UNITED STATES PATENT AND TRADEMARK OFFICE

APPLICATION NO.	FILING DATE	FIRST NAMED INVENTOR	ATTORNEY DOCKET NO.	CONFIRMATION NO.
10/626,980	07/25/2003	Helmut Laig-Hoerstedbrock	054821-0863	4136
26371	7590	07/22/2005	EXAMINER	
FOLEY & LARDNER 777 EAST WISCONSIN AVENUE SUITE 3800 MILWAUKEE, WI 53202-5308			TIBBITS, PIA FLORENCE	
			ART UNIT	PAPER NUMBER
			2838

Office Action Summary

DETAILED ACTION

Fig. 1

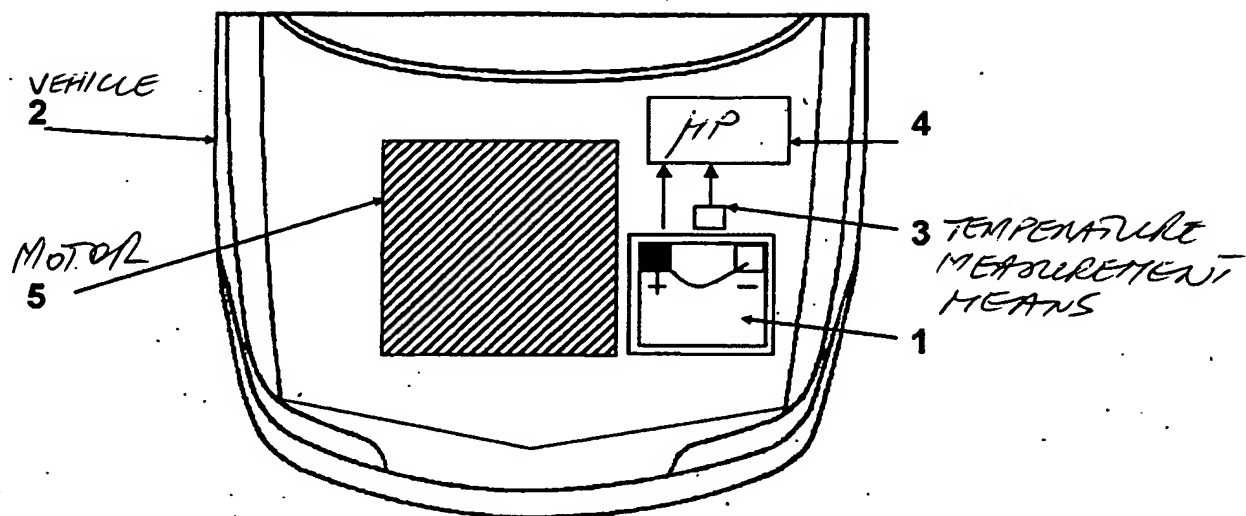
1. The drawings are objected to under 37 CFR 1.83(a) because they fail to show the conventional names, as described in the specification, e.g. vehicle, motor, temperature measurement means, etc. for the elements shown in fig.1 with non-conventional symbols. Corrected drawings in compliance with 37 CFR 1.121(d) are required in reply to the Office action to avoid abandonment of the application. The replacement sheet(s) should be labeled "Replacement Sheet" in the page header (as per 37 CFR 1.84(c)) so as not to obstruct any portion of the drawing figures. If the examiner does not accept the changes, the applicant will be notified and informed of any required corrective action in the next Office action. The objection to the drawings will not be held in abeyance.

APPROVED WITH
COMMENTS 7/19/05
OIPF JC187
APR 11 2005
PATENT & TRADEMARK OFFICE
